DWR Questions dated October 1, 2026

USACE Questions dated October 2, 2026

WRC Permitting Comments, October 2, 2026

NC DEPARTMENT OF TRANSPORTATION
DIVISION OF HIGHWAYS
OCTOBER 2026
HENDERSON COUNTY
18314.1045039
GERTON HWY - US 74

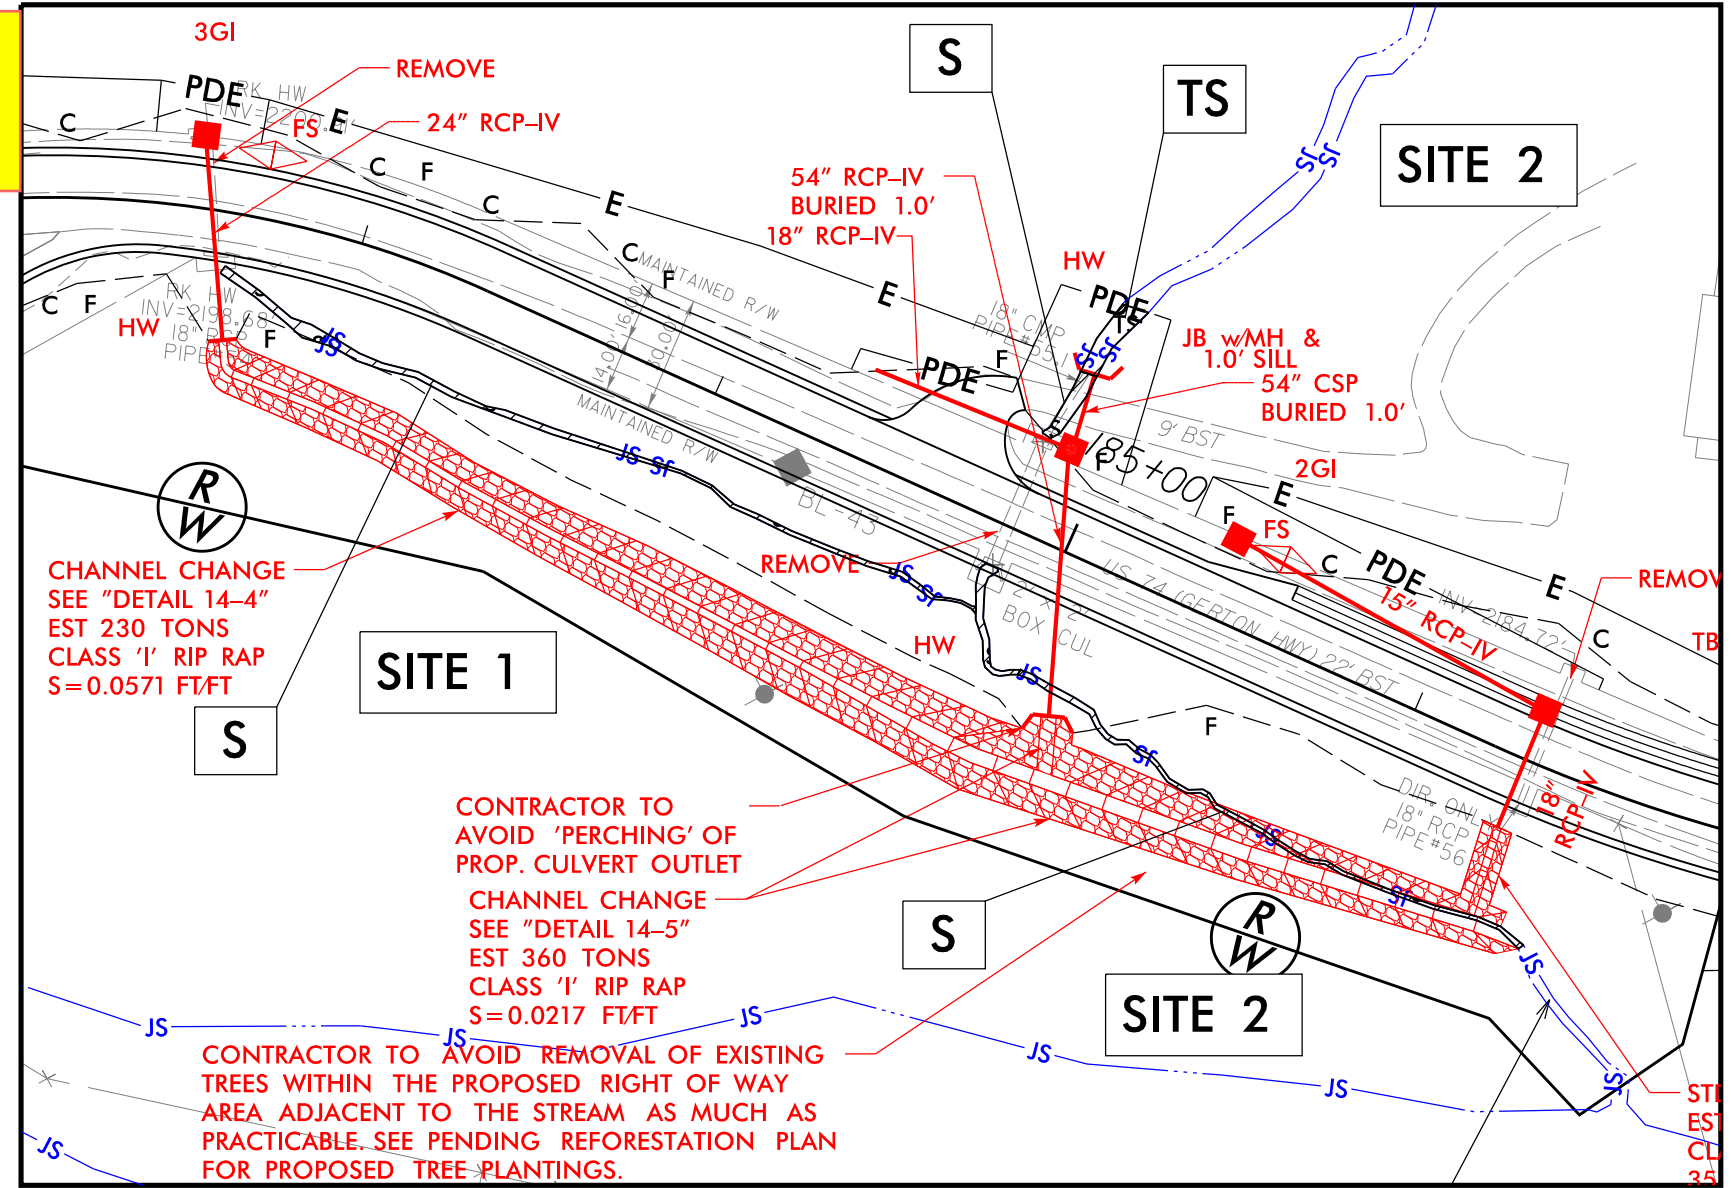
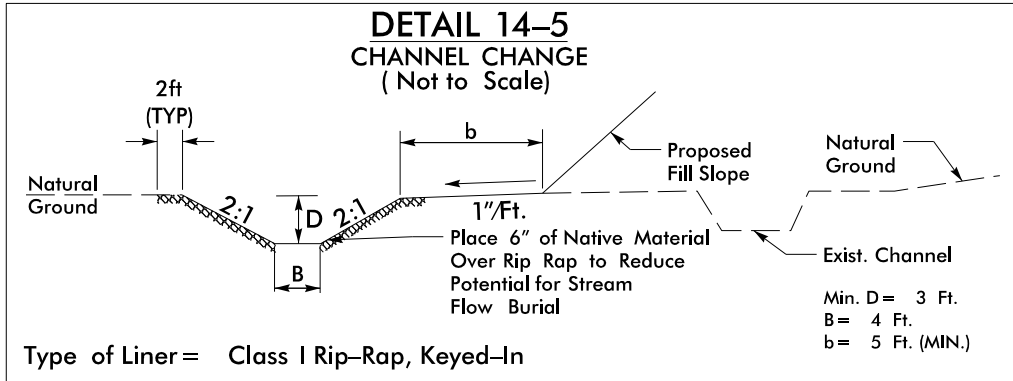
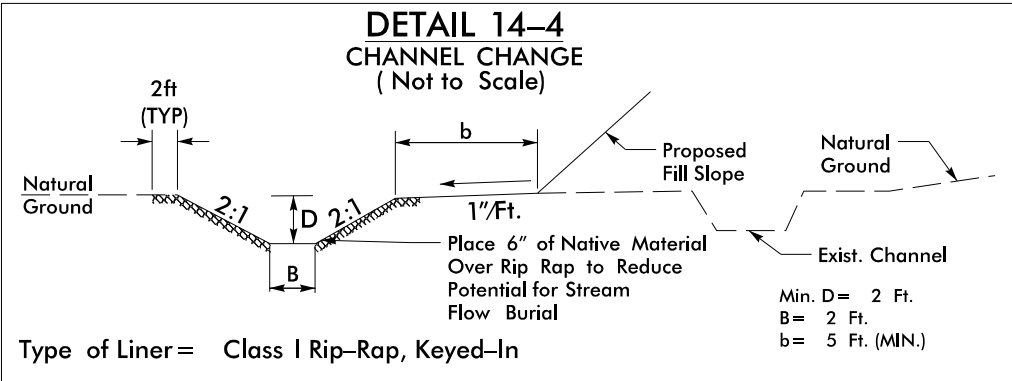
1. Site 2 - UT Hickory Creek channel change (site 2) is oriented at a right angle to the confluence with UT Hickory Creek (Site 1 channel change) – can this angle be altered so it is not perpendicular to the streambank?

Site 2:
Adjusting for a better angle into UT, and
reducing permanent impact by 30 lf and
temporary by 15 lf.

PERMIT DRAWING
SHEET 17 OF 29

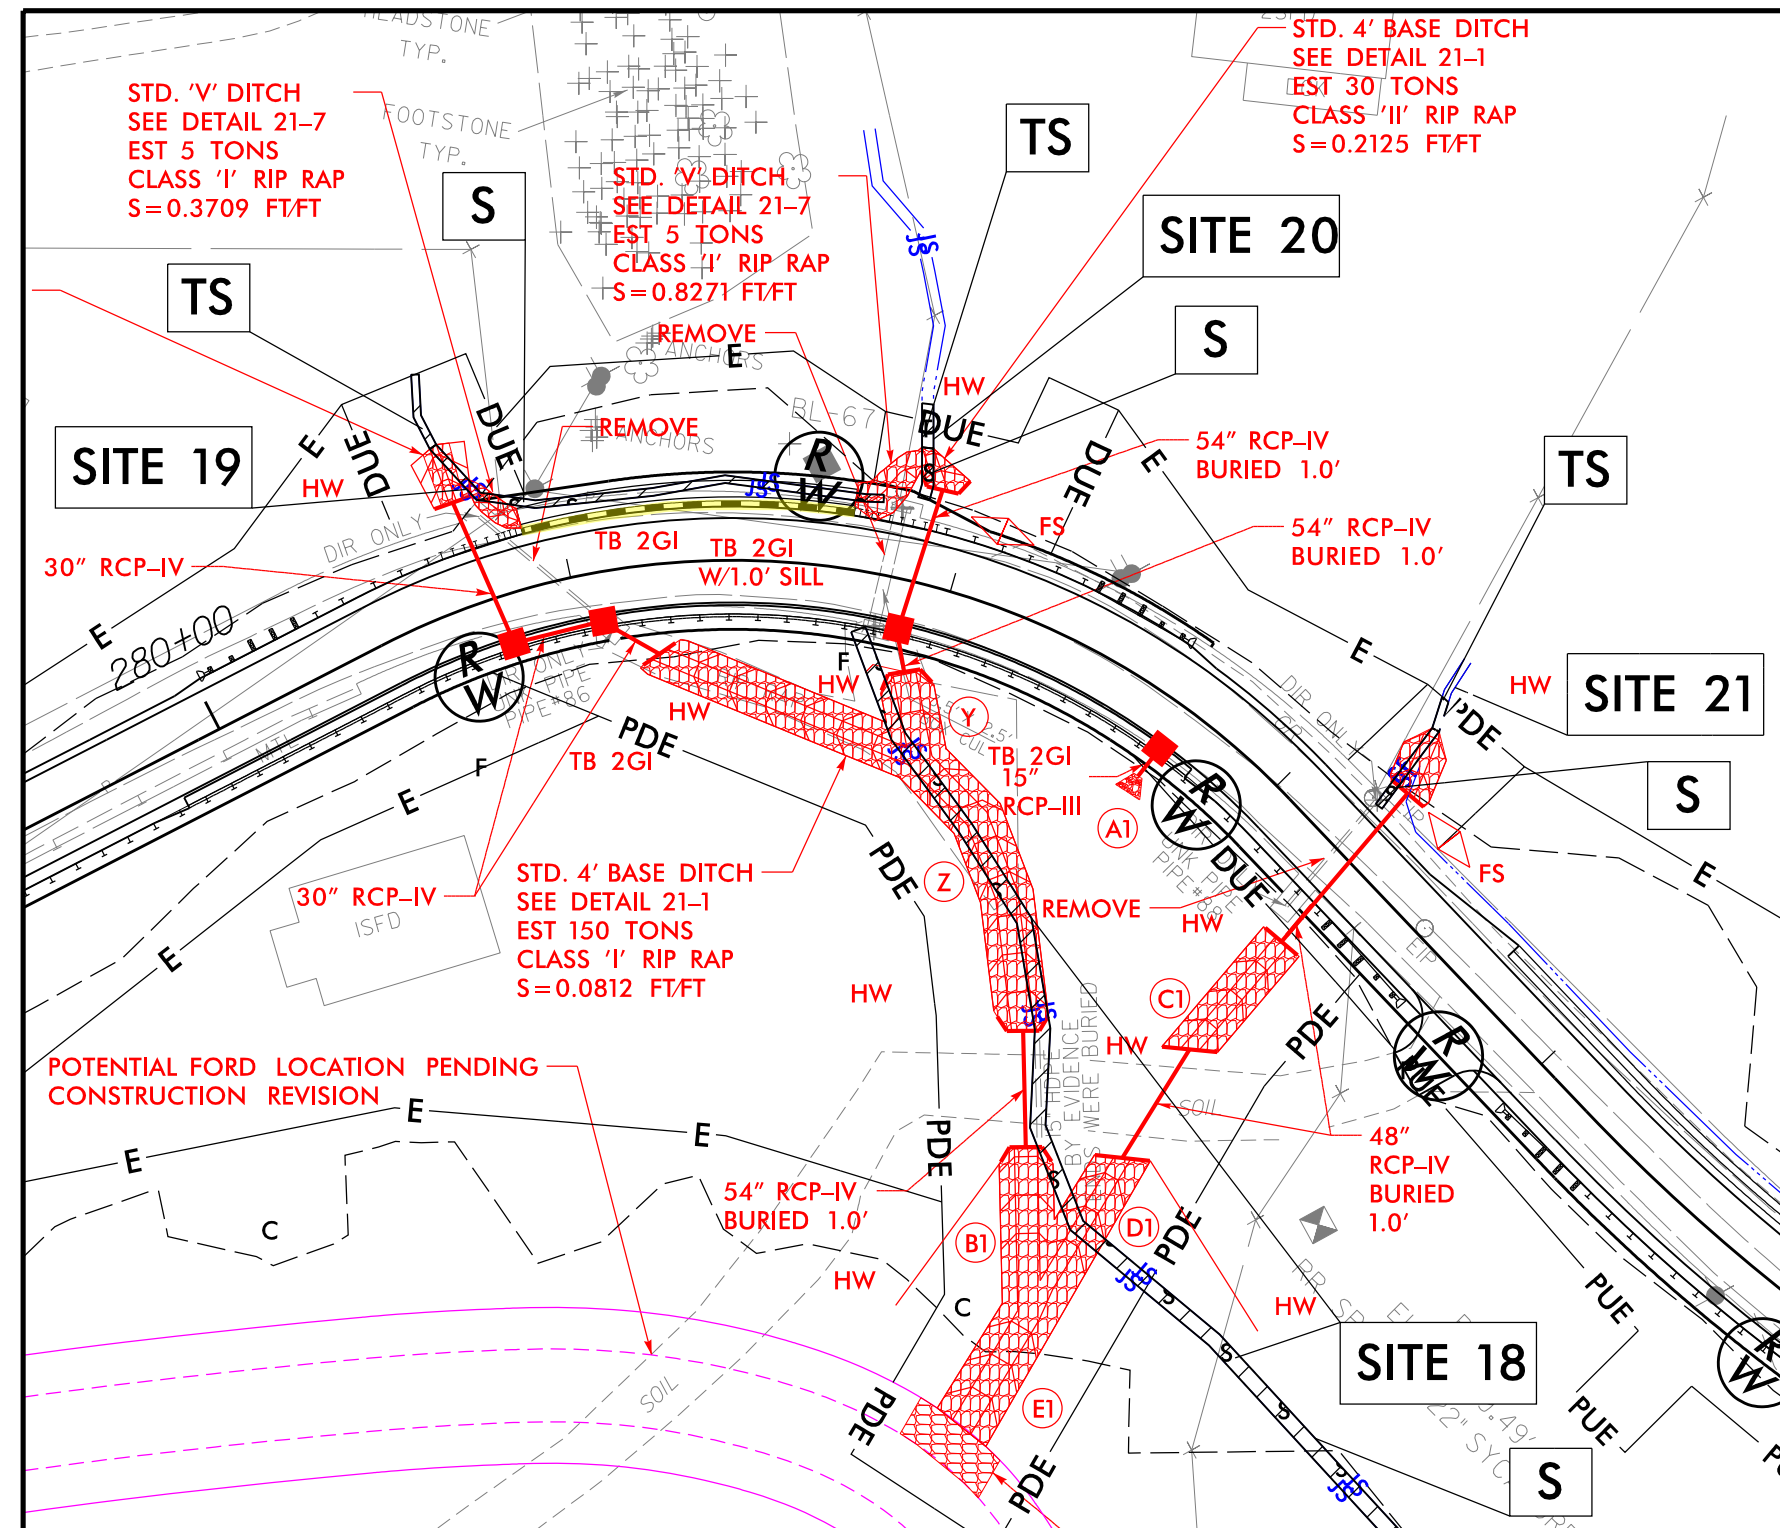
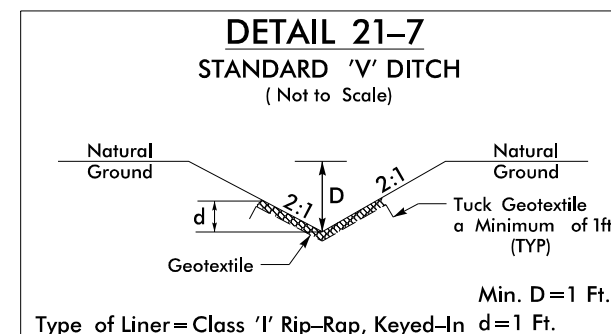
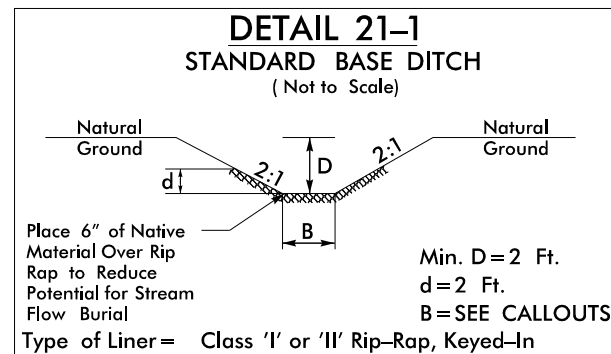
8. Can the different parts of the wall below 74A be identified? There is different symbology shown on the plans and I am curious what they mean. Is the entire wall footprint above OHW mark?

- Sheet 17 of 29 - Why are they relocating the stream when it's this far from the road? They are literally moving it closer to the road in places.

The retaining walls are located at Site 17 (PD Sheets 17 and 19) and Site 19 (PD Sheet 21) and have been highlighted in yellow on the drawings.

Gray areas, as noted in the image below, found at the base of the Partially Grouted Rock are imbedded below the stream. The retaining wall footprints are above the OHW mark.

The proposed stream relocation returns the stream to its pre-Helene alignment with a single channel, instead of a multi-braided channel created by the storm. Further, as shown on the topographic sheet 18, this is another area where the channel is quite narrow with steep slopes. The channel has been relocated to not create greater impacts to the road.

PERMIT DRAWING
SHEET 21 OF 29

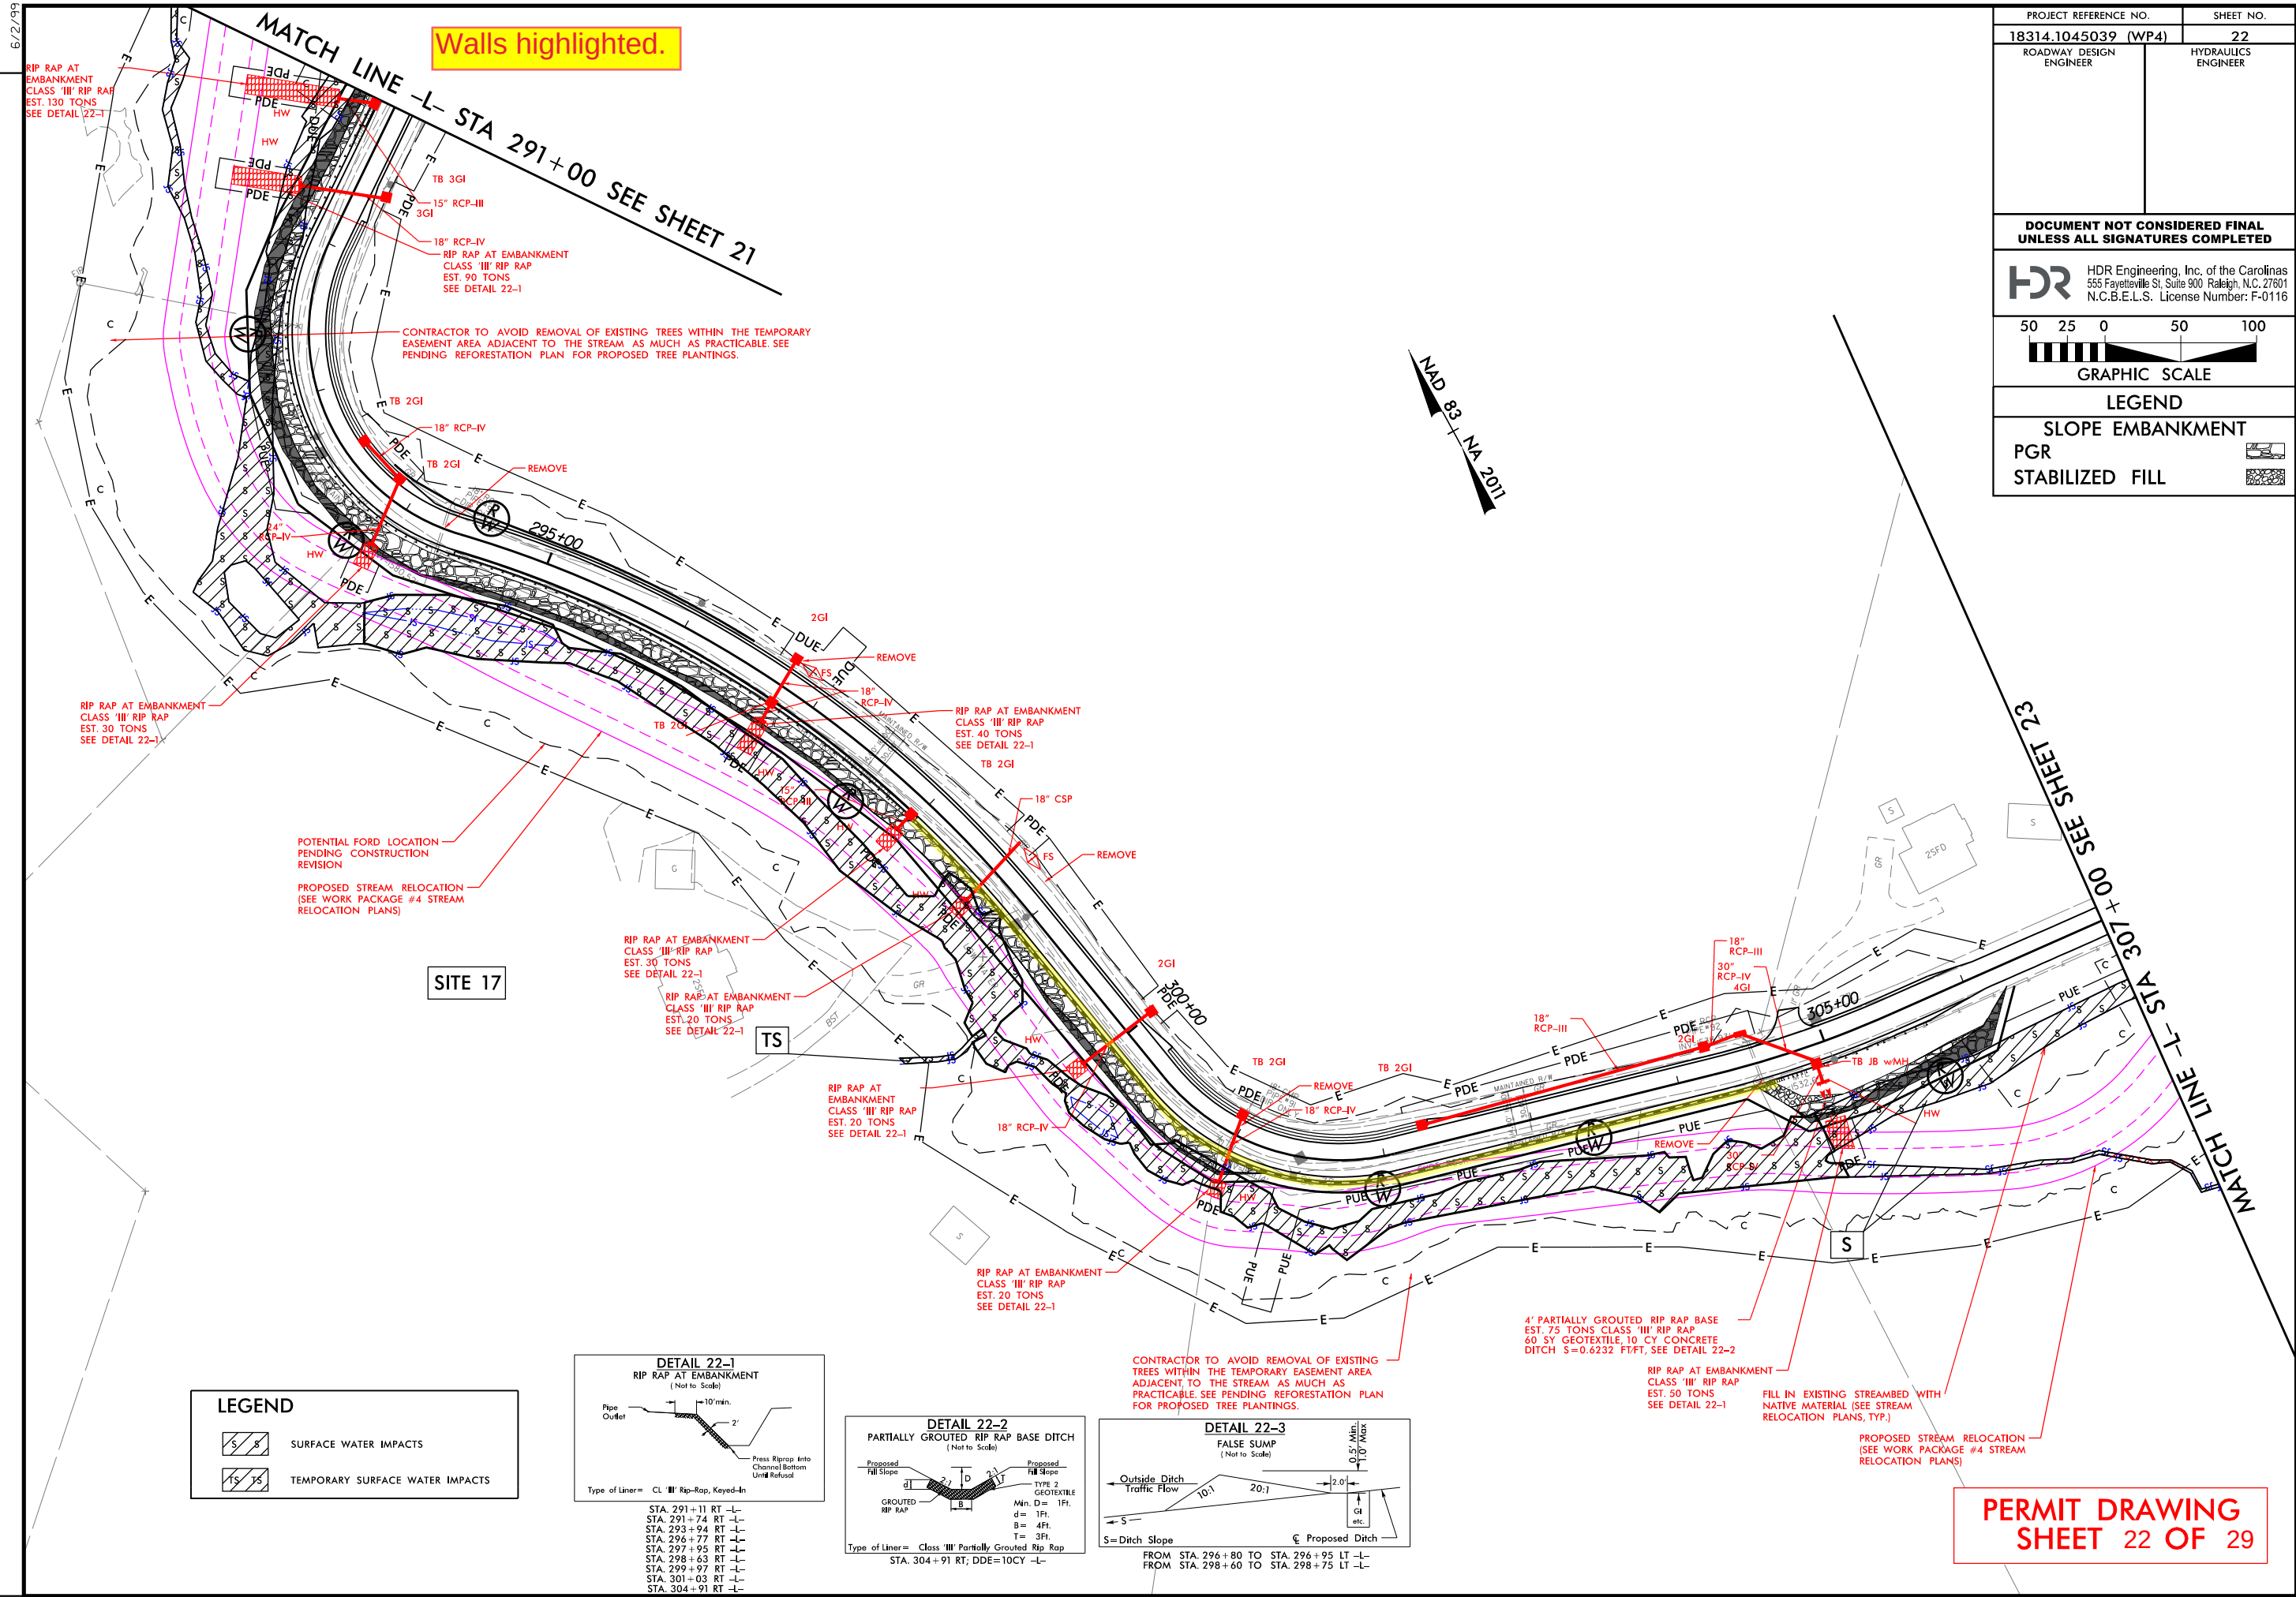
- Sheet 21 of 29 - Where is this stream currently going? Will the flow pattern remain?

This UT drains through the existing culvert towards Hickory Creek. The downstream outlet of the pipe was not found in the field and may be buried by rock and debris.

The flow pattern will be maintained towards Hickory Creek via a proposed rip rap armored channel.

Walls highlighted.
